SUBJECT: SAFETY EVALUATION OF GE TOPICAL REPORT, NEDC-31858P, REVISION
2; "BWROG REPORT FOR INCREASING MSIV LEAKAGE LIMITS AND
ELIMINATION OF LEAKAGE CONTROL SYSTEMS," SEPTEMBER 1993

SAFETY EVALUATION BY THE OFFICE OF NUCLEAR REACTOR REGULATION
BWROG GENERIC RESOLUTION
FOR THE BWR MAIN STEAM ISOLATION VALVE LEAKAGE

FIG. 11

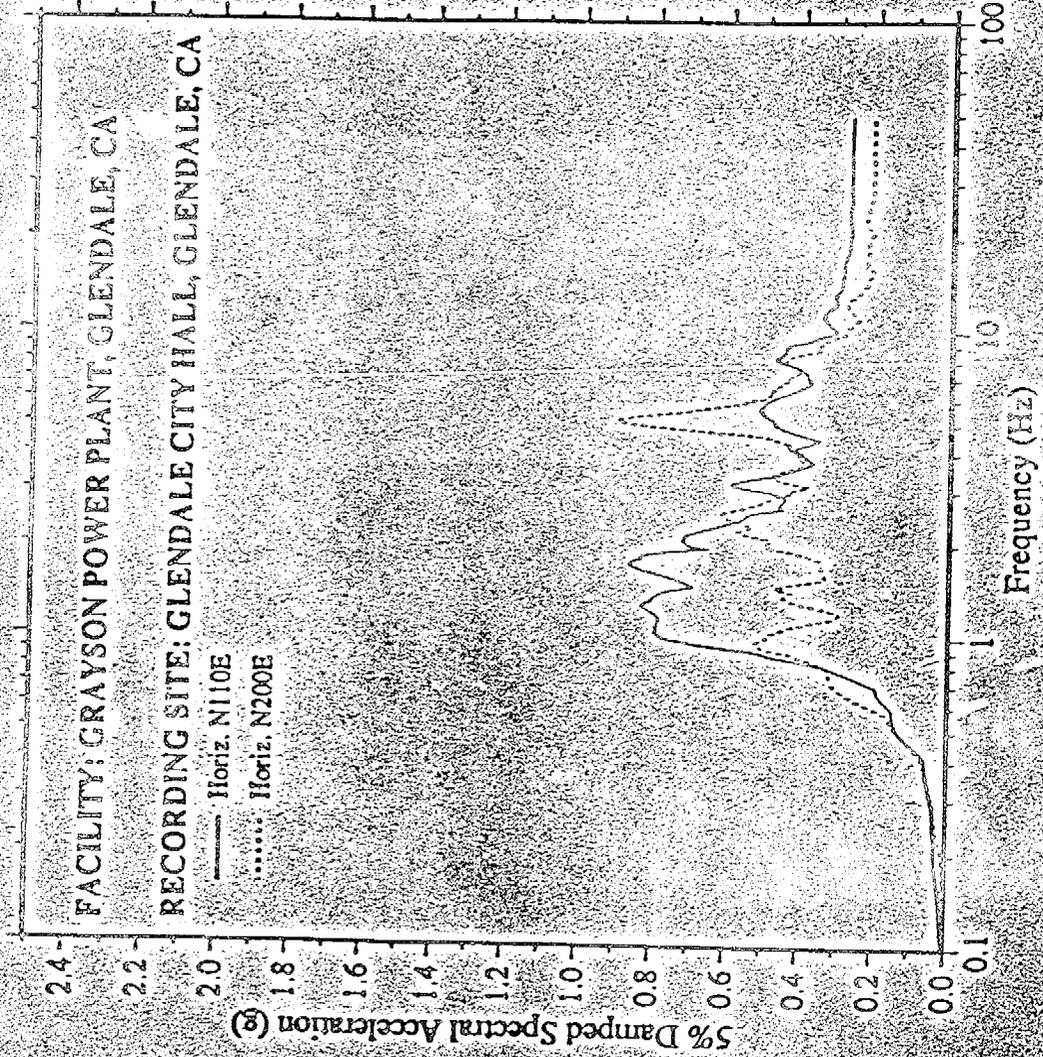
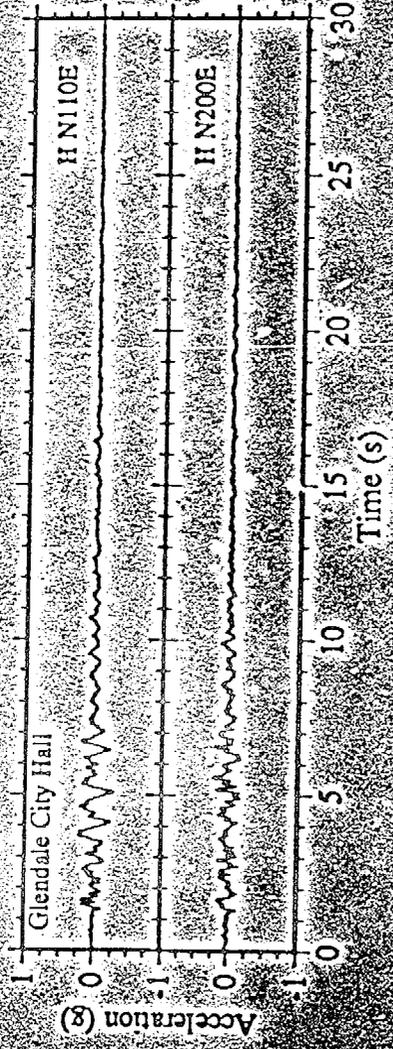
The Grayson Power Plant in Glendale, CA, is located about 2 km from the Glendale City Hall. The latest EQE earthquake experience database (Reference 5) incorrectly gives a facility-to-recording site distance of 16 km. Both the facility and recording site are located on similar thicknesses of alluvium and therefore, the recording of the 1971 M6.6 San Fernando earthquake made at Glendale City Hall is an acceptable estimate of the ground motion at the Grayson Power Plant (Figure 11). Similarly, the Port Hueneme Naval Laboratory recording of the 1973 M5.6 Point Mugu earthquake, shown in Figure 12, is an acceptable estimate of the ground motion at the Ormond Beach Power Plant in Port Hueneme, CA.
